Technical Service Information

THM 440-T4 CONVERTER CLUTCH SHUDDER

Figure 1

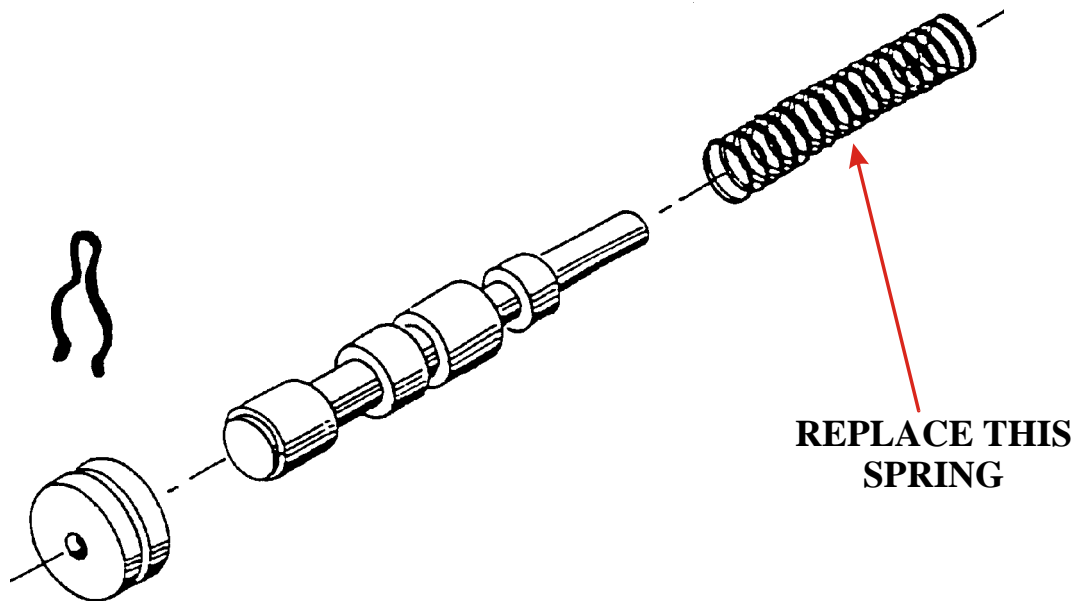
COMPLAINT: Converter clutch shudder on any THM 440-T4.

CAUSE: The cause may be, not enough converter apply pressure as the factory has it calibrated at about 45 PSI.

CORRECTION: There is now available from the aftermarket suppliers a spring for the converter clutch regulator valve that raises the apply pressure to 61 PSI, and eliminates converter clutch shudder (See Figure 1).

The spring is available under part number SGSF-440.
